Standardized Nuclear Unit
Power Plant System

SLNRC 84-0085 FILE: 0278
SUBJ: Callaway Plant Ultimate
Heat Sink Technical
Specification Requirements

Docket No.: STN 50-483

CALLAWAY UHS
 RETENTION POND
 LEVEL VS VOLUME

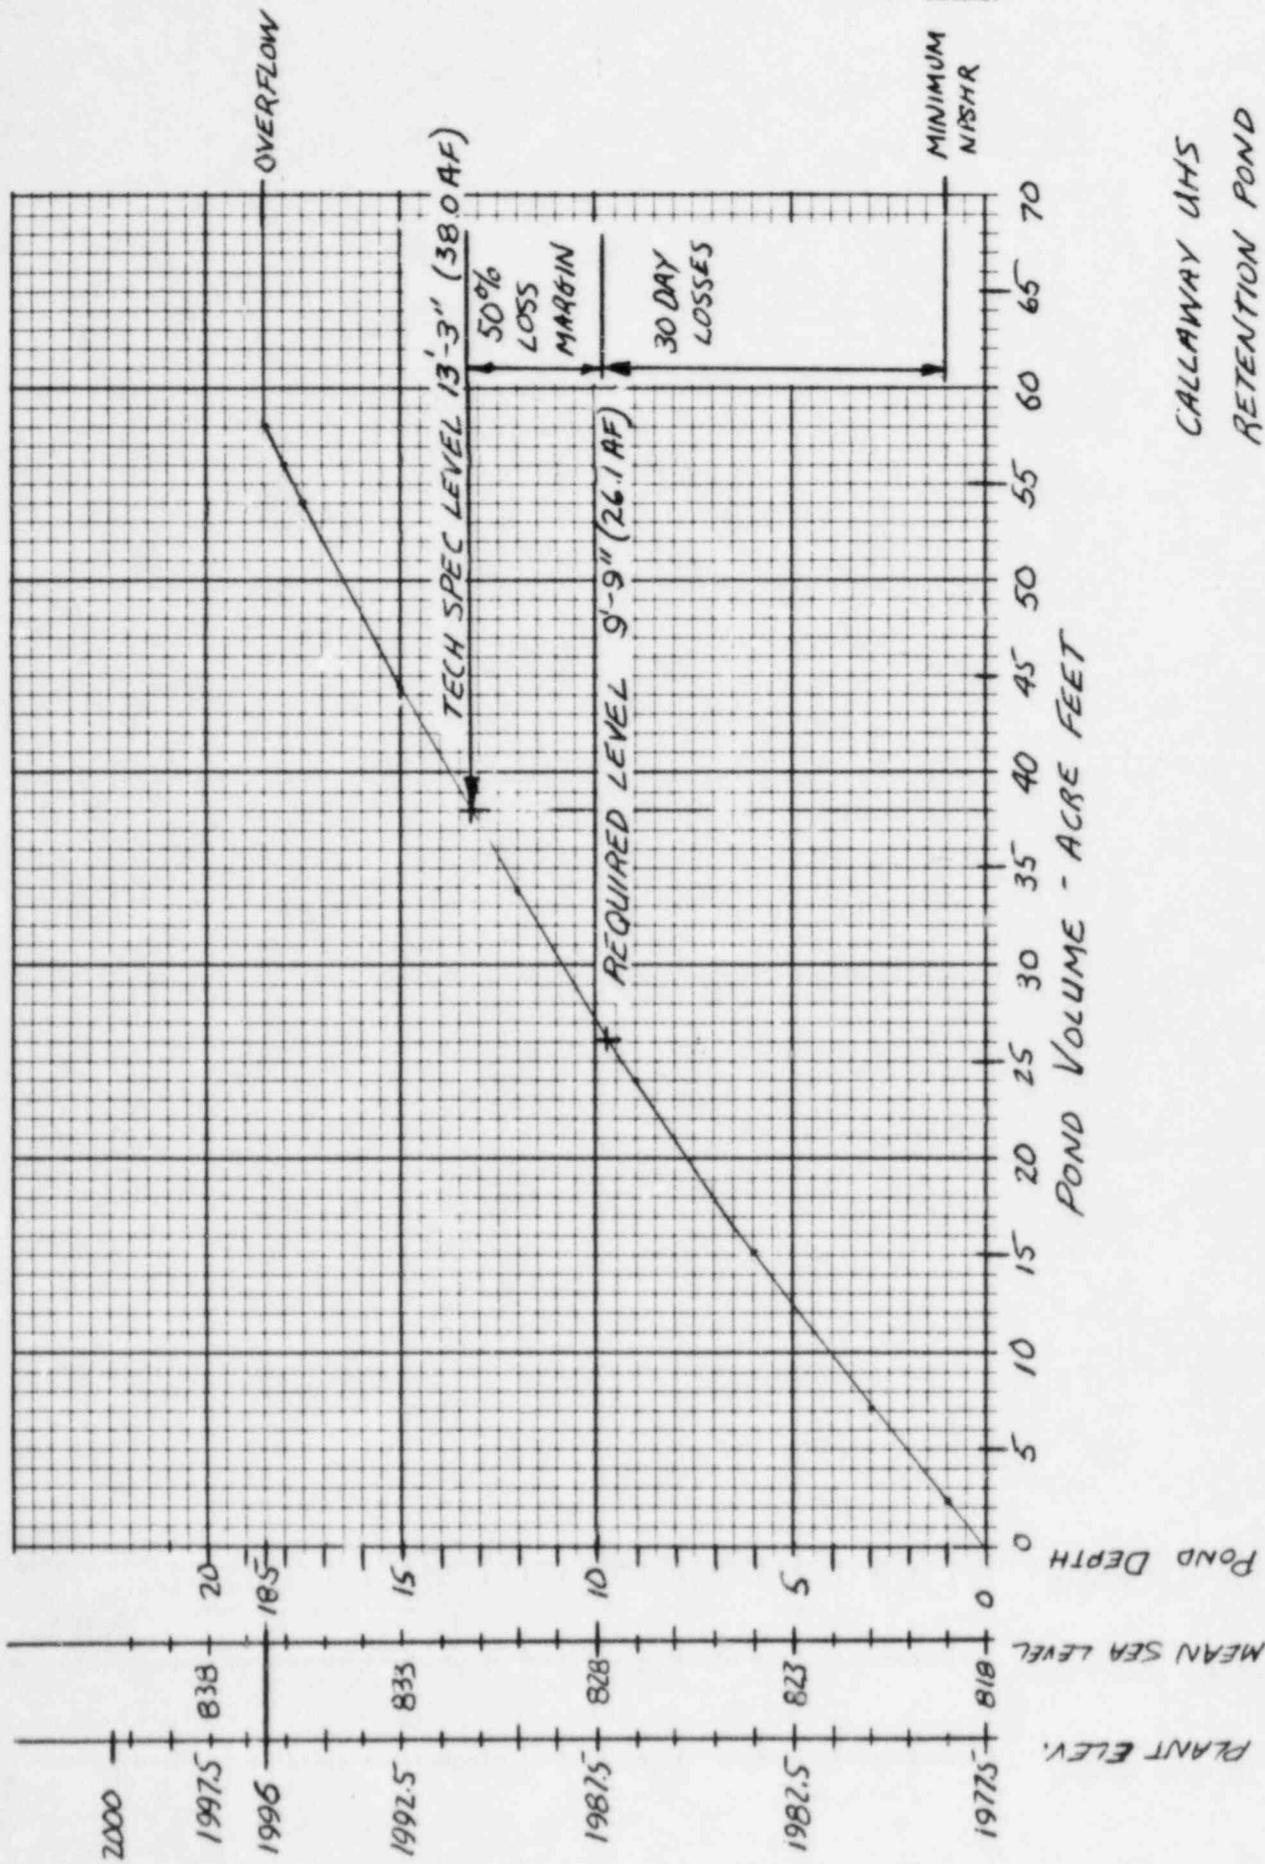
A calculation has been performed to determine the appropriate UHS water level for a single 3425 MWT unit. The calculation used the same conservative analytical methods described in the SNUPPS FSAR and Callaway FSAR Site Addendum for the two-unit calculation. The result of this calculation is a UHS water level of 9.75 ft. To this level, an additional 50% margin has been added to establish a new Technical Specification limit of 13.25 ft. The enclosed figure reflects the results of the calculation for one nuclear unit.
